APPLICATION FOR PERMIT TO DRILL OR REENTER

2. Name of Operator Energen Resources Corporation		7. Unit or CA Agreement Name and No.
3a. Address 2198 Bloomfield Highway Farmington, New Mexico 87401		8. Lease Name and Well No. Hart Canyon 3 #2S
3b. Phone No. (include area code) (505) 325-6800		9. API Well No. 30-045-33112

SUNDRY NOTICES AND REPORTS ON WELLS

Energen Resources plans to make the following changes to the Hart Canyon 3 #2S well:

HART CANYON WELL NO. 2
45° MOTHERBORE/UPPERFLOWER
RIO ARriba COUNTY, NM
Plan #1 revised

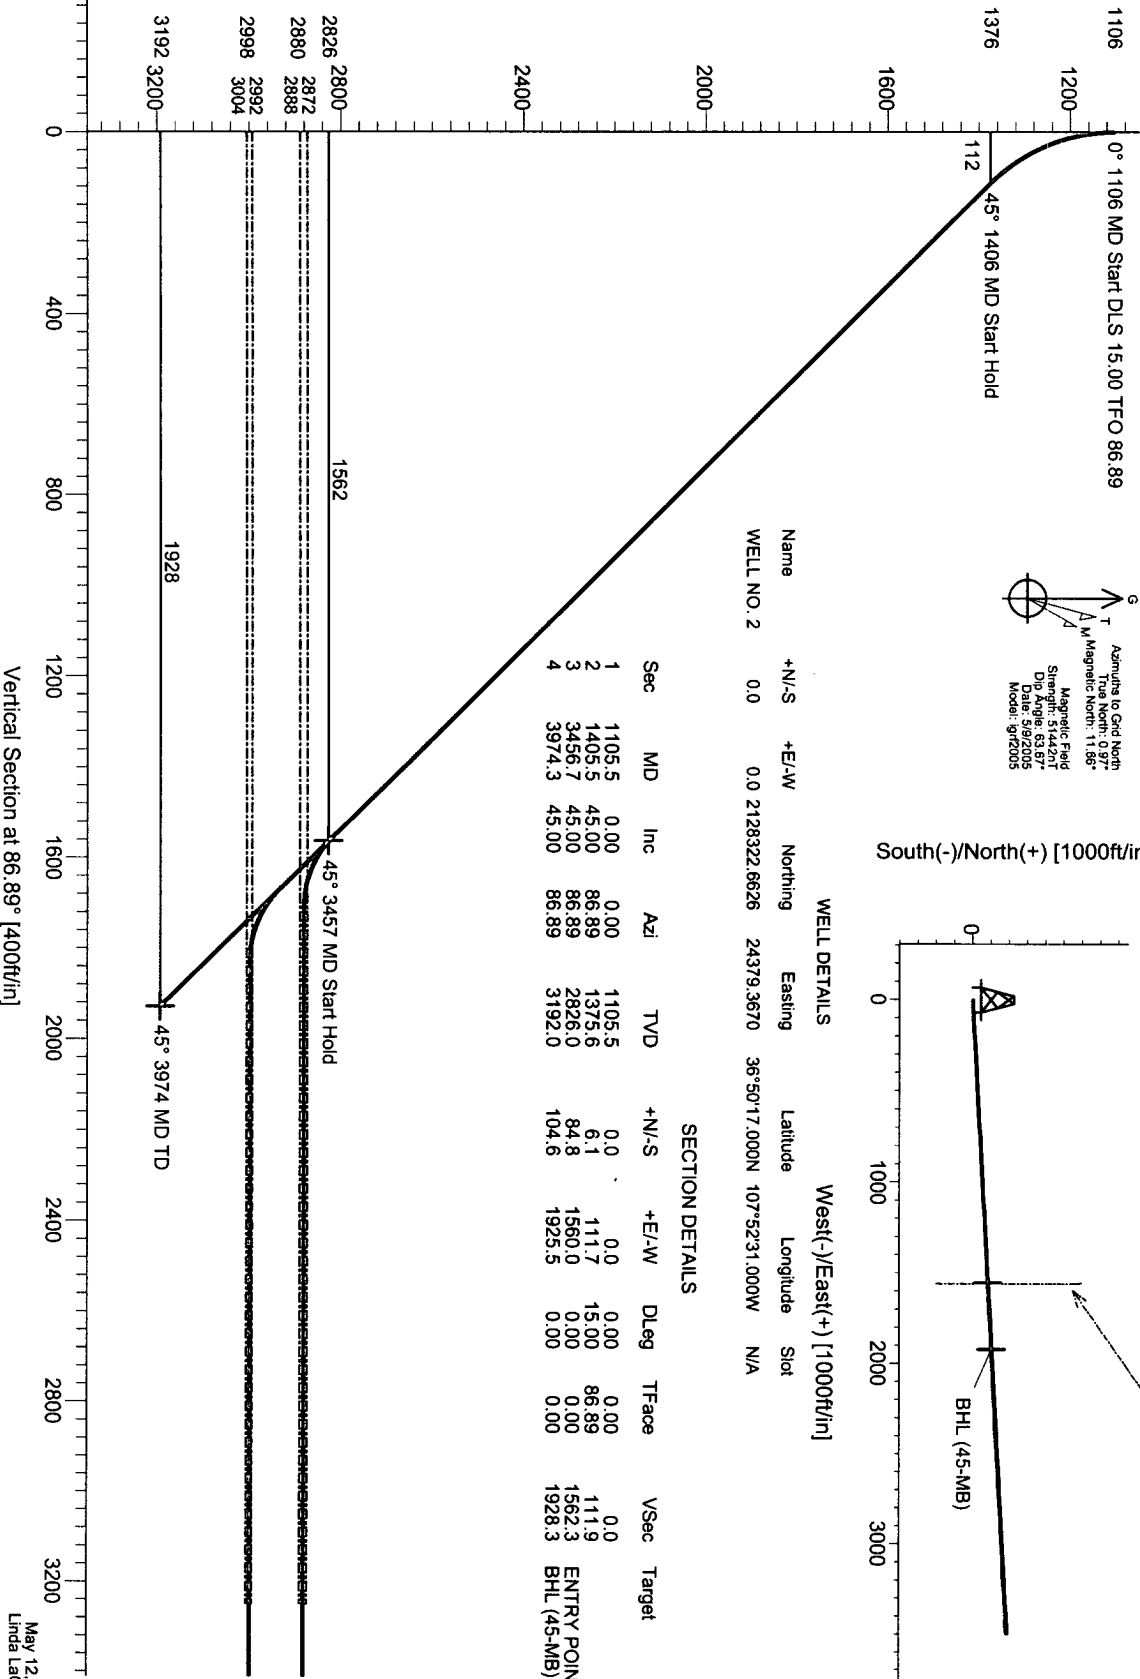
- * Change the intermeditate wellbore from a 45 deg deviation to a 66 deg deviation as indicated in the attached directional drilling plan with a new setting depth of 4593' (MD).
- * Change the lower production liner top and setting depth to 4060' - 5815' (MD), TVD remaining the same.
- * Change the upper production liner top and setting depth to 3770' - 5790' (MD), TVD remaining the same.
- * Change the intermediate cement volumes to 575 sks of lead followed by 225 sks of tail (1406 cu.ft.).
